SUBJECT: Docket 71-9239, Model Nos. MCC-3, 4, 5 Packages, Approval for Shipment of Modified Fuel Assembly Contents

**Responses to Request for Additional Information
Westinghouse Electric Company, LLC
Docket No. 71-9239
Certificate of Compliance No, 9239
Model Nos. MCC-3, MCC-4, And MCC-5**

Enclosure 3 - Evaluations, Analysis and Detailed Calculations– Annular Pellet Blankets (Revision 1)

Figure 6-5

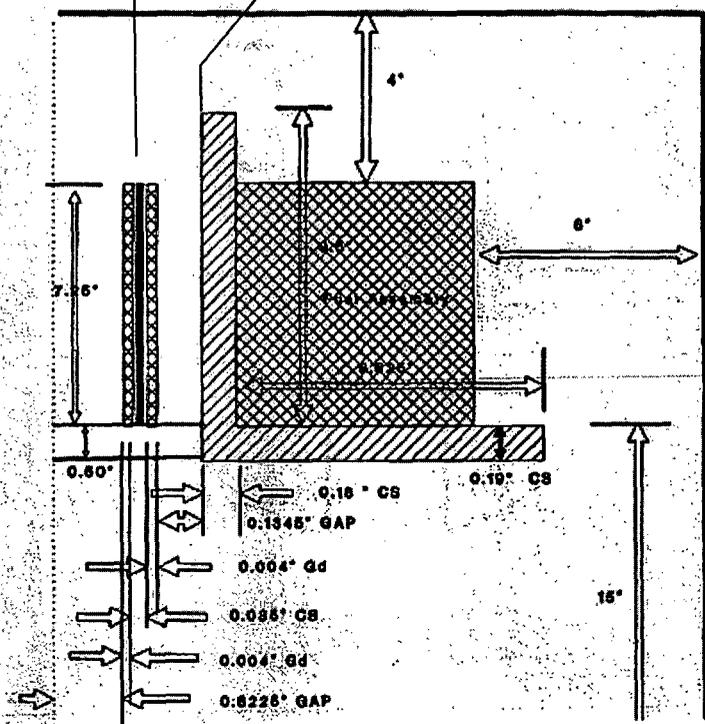
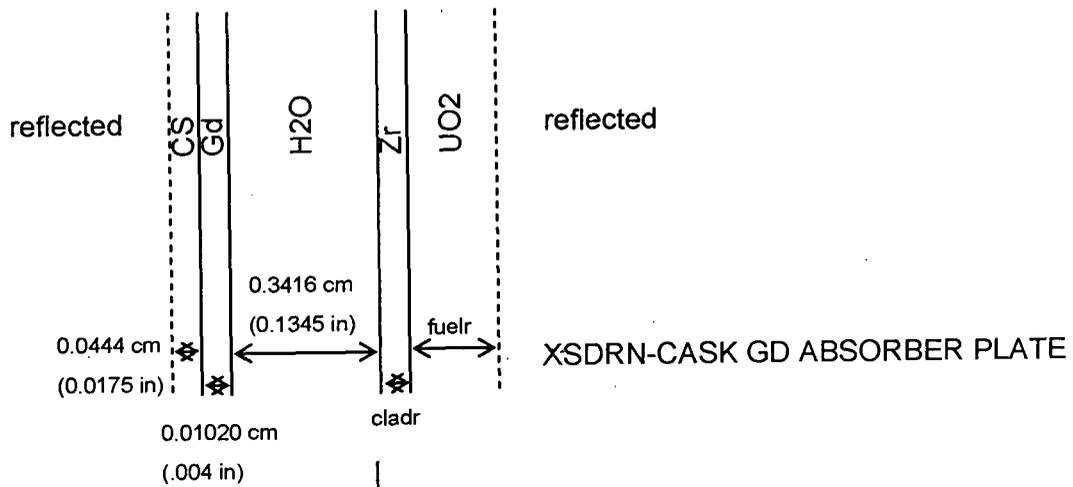
It is unclear why the asymslabcell was needed in the input file. A justification is needed to ensure that the code was used properly.

better unresolved resonance techniques. The ASYMSLABCELL CELLDATA card was used in an attempt to replicate this XSDRN input in the original application in SCALE 5.1. The XSDRN input for the Gadolinium absorber plate is shown in the figure below as it relates to the actual configuration in the package. The Gadolinium absorber plate and fuel region was represented as a slab geometry in the XSDRN input as an attempt to represent within the limitation of the 1-D geometry. It may have been more accurate to have calculated a cell-weighted cross section by represent the fuel lattice as an homogenized cross section generated from a 1-D XSDRN calculation representing the fuel rod lattice. Notwithstanding, these XSDRN calculations were used in the original application to calculate a flux spectrum that would be representative of that seen by the Gadolinium absorber plate in order to weight the fine group cross sections for collapsing to a 27 group energy structure. The SCALE 44 group cross-sections are used in the calculations in this request, therefore replicating the cell-weighting flux calculation done by XSDRN in the original application is not necessary.

The choice of the geometry for the unit cell input is important to account for the effect lattice geometry by calculating the Dancoff factor that is used to modify the resonance escape probability used in the Nordheim Integral Treatment as done in NITAWL. The applicant agrees that use of ASYMSLABCELL is not appropriate for replicating the resonance calculations for the gadolinium isotopes as done in the original application. The Gadolinium absorber plate is not a repeating structure and as such should not be represented as such by a LATTICECELL, SYMSLABCELL, or ASYMSLABCELL. Instead a MULTIREGION slab geometry is more appropriate to replicate the NITAWL input for Gadolinium resonance calculations as done in the original application. The MULTIREGION option does not calculate a Dancoff factor and instead defaults the value used to zero as in the case of a homogeneous infinite medium. However, the INFHOMOGENOUS resonance treatment for Gadolinium isotopes would not account for corrections to the resonance escape probability due to the slab geometry, and it use would overstate the correction to the infinite dilute resonance integral resulting in decreased resonance absorption. Specifying LATTICECELL SQUAREPITCH for the solid pellet stack and LATTICECELL ASQUAREPITCH for the annular pellet stack does replicate the geometry used in the original NITAWL input and includes the additional treatment of the annular region not done in earlier versions of NITAWL.

Figure 1-Annular Pellet Geometry

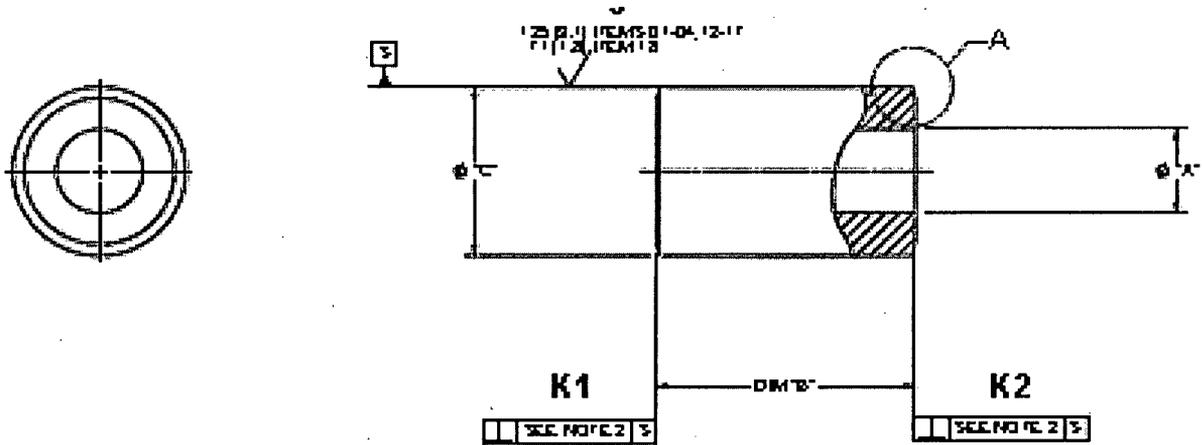
Figure 1 appears to have dimensions on it, but they are not legible. Figure 2 provides a diagram of the annular pellet blanket, however the dimensions are not provided. The dimensions are necessary for the staff to do an independent confirmatory calculation.

Figure 1 shows the configuration for an annular blanket pellet. There are 15 annular blanket pellet specifications with 7 unique inside and outside radial dimensions for the configuration shown in Figure 1. The fuel assembly parameters are conditions of approved contents in the CoC by reference to Tables 1-5-1 through 1-5-5 in Section 1- General Information, Appendix 1-5 of the application. The nominal pellet outside diameter and annular pellet inner diameter can be found in Appendix 1-5 for each type of the fuel assembly, and a summary of these diameter dimensions is provided in the following table. Annular inner diameter is not specified in Appendix 1-5 for fuel assembly types CE-1, CE-2, and CE. The CE fuel assembly types are shipped in the Traveller package USA/9297/AF-96 and CoC 9297 condition 5.(b)(1)(v) does not limit the length of the annular pellet blanket.

Figure 1 shows the configuration for an annular blanket pellet. There are 15 annular blanket pellet specifications with 7 unique inside and outside radial dimensions for the configuration shown in Figure 1. The fuel assembly parameters are conditions of approved contents in the CoC by reference to Tables 1-5-1 through 1-5-5 in Section 1- General Information, Appendix 1-5 of the application. The nominal pellet outside diameter and annular pellet inside diameter can be found in Appendix 1-5 for each type of the fuel assembly, and a summary of these diameter dimensions is provided in Table 1. Annular inner diameter is not specified in Appendix 1-5 for fuel assembly types CE-1, CE-2, and CE. The CE fuel assembly types are shipped in the Traveller package USA/9297/AF-96 and CoC 9297 condition 5.(b)(1)(v) does not limit the length of the annular pellet blanket.

Figure 4 - Lattice Cell model for Fuel rods

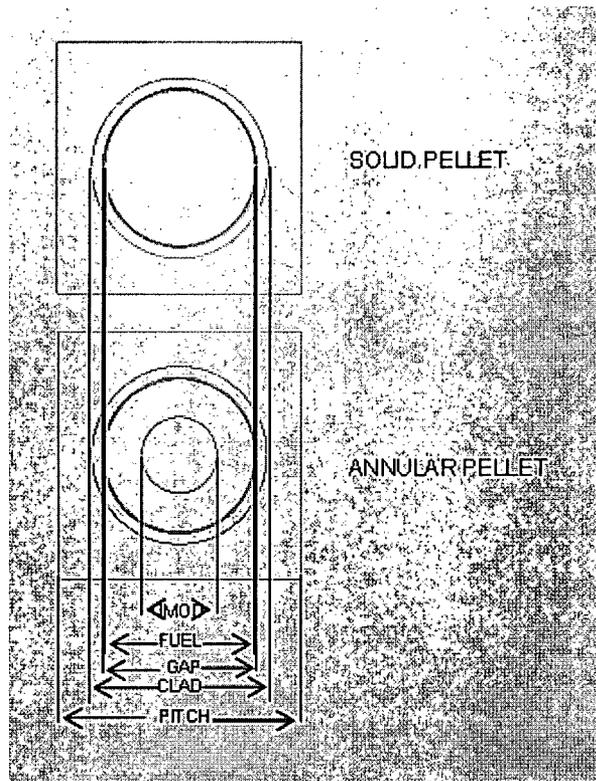
The dimensions used for the cross section processing in the input file are not consistent with the geometry used to describe the fuel rods. A justification of the reason behind the different dimensions used is needed.

Figure 2 relates the dimensions used to specify the lattice cell parameters used by the SCALE CSAS control module to the fuel assembly type lattice dimensions in Appendix 1-5. The lattice cell model input parameters correspond to the fuel assembly description as follows,

- IMOD Annular Pellet Inner Diameter
- FUEL Nominal Pellet Diameter
- GAP Nominal Clad Outer Diameter minus (2 X Nominal Clad Thickness)
- CLAD Nominal Clad Outer Diameter
- PITCH Nominal Lattice Pitch

Radius or diameter may be specified in the CELLDATA block. The radius dimensions were specified in the CELLDATA block for consistency with the dimensions required in the GEOMETRY block.

The same packaging model described in Section 6.3.1 of the application is used. Annular pellets are represented by the geometry dimensions shown in Figure 4 for the purpose of providing self-shielded cross sections. The LATTICECELL input parameters shown in Figure 4 correspond to the fuel assembly description in Appendix 1-5 of the application as follows,

IMOD	Annular Pellet Inner Diameter
FUEL	Nominal Pellet Diameter
GAP	Nominal Clad Outer Diameter minus (2 X Nominal Clad Thickness)
CLAD	Nominal Clad Outer Diameter
PITCH	Nominal Lattice Pitch

Radius or diameter may be specified in the LATTICECELL parameters. The radius dimensions were specified in the LATTICECELL block for consistency with the radial dimensions as required in the GEOMETRY block.

Figure 6 - Effect of Annular Pellets and Moderating Diametric Gap

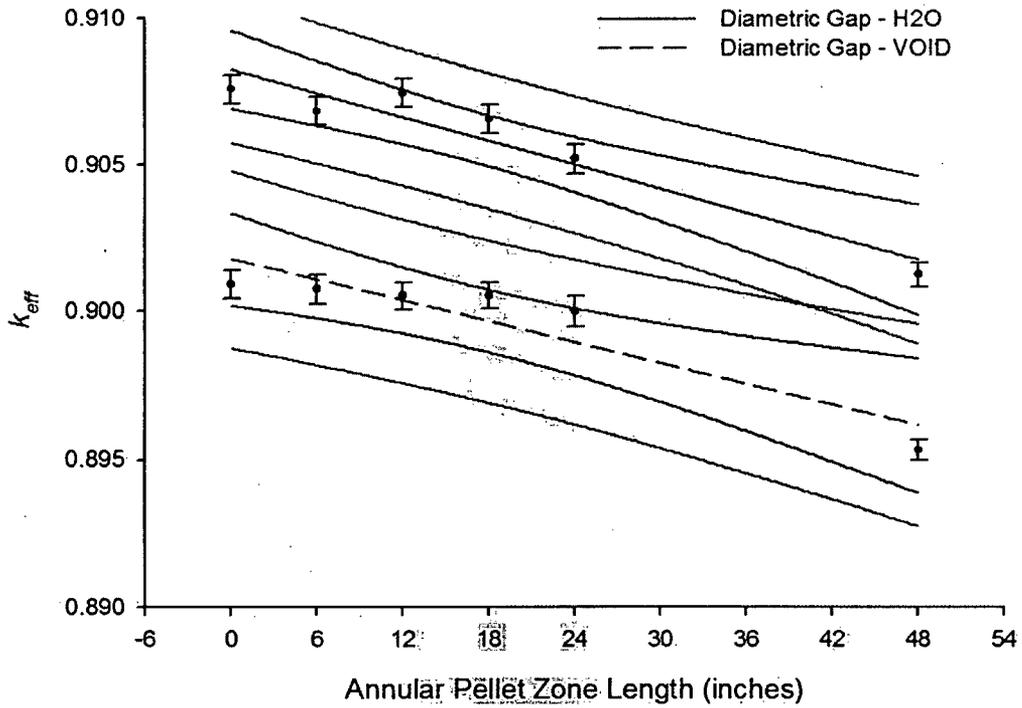
The application gives the keff for the modified assembly surrounded by water but does not discuss how the packaging may affect criticality. The staff request a demonstration showing that the modified assembly is subcritical when considering packaging or a demonstration showing that the modified assembly is still bounded by the Type A evaluation in the application.

The self-shielded cross sections are used in a detailed Monte Carlo transport calculation (KENO Va) that accounts the geometry and material composition of the fuel rod lattice and packaging components. Results for these calculations as summarized in Figure 6 and Table 4 reveal the separate effect that annular pellets and moderating the diametric gap have on reactivity. The change in k_{eff} due to moderating the diametric gap is on average $0.006 \Delta k_{eff}$, and k_{eff} decreases due to increasing the annular pellet zone length. Evaluating both effects separately demonstrates that increasing the annular pellet zone length causes a decrease in k_{eff} value; therefore, imposing a limit on annular pellet zone length is not necessary. All "95/95 w/Bias" values regardless of the annular pellet zone length are less than the maximum allowed value of $k_{eff}=0.9500$.
